MILITARY SPECIFICATION

FASTENER, CASE FOR EQUIPMENT RACK SYSTEM IN AIRCRAFT

* This amendment forms a part of Military Specification MIL-F-8490A, dated 28 Feb 1958, and is approved for use by the Department of the Air Force and is available for use by all Departments and Agencies of the Department of Defense.

1. DOCUMENT NUMBER	2. DOCUMENT TITLE
MIL-F-8490A Amendment 4	FASTENER CASE FOR EQUIPMENT RACK SYSTEM IN AIRCRAFT

FIGURE 2. Fastener assembly aircraft equipment panel

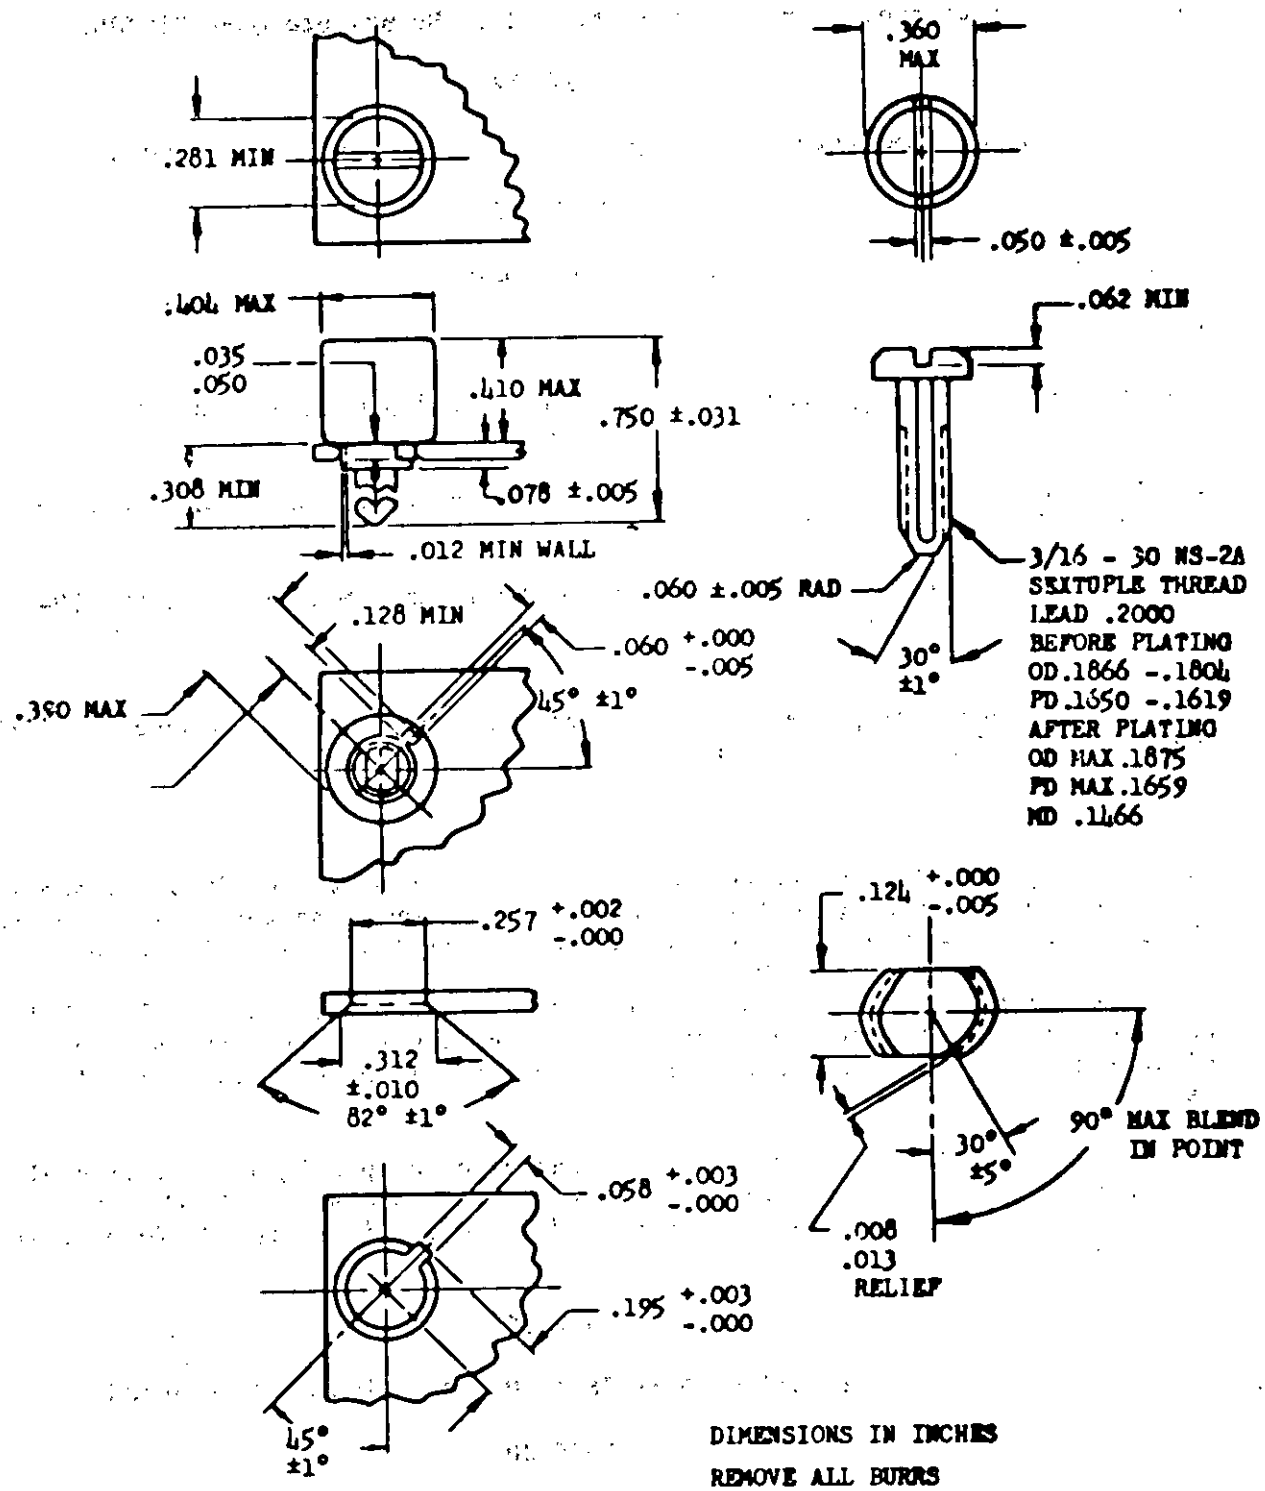
Figure 2, delete and substitute new figure 2 attached.
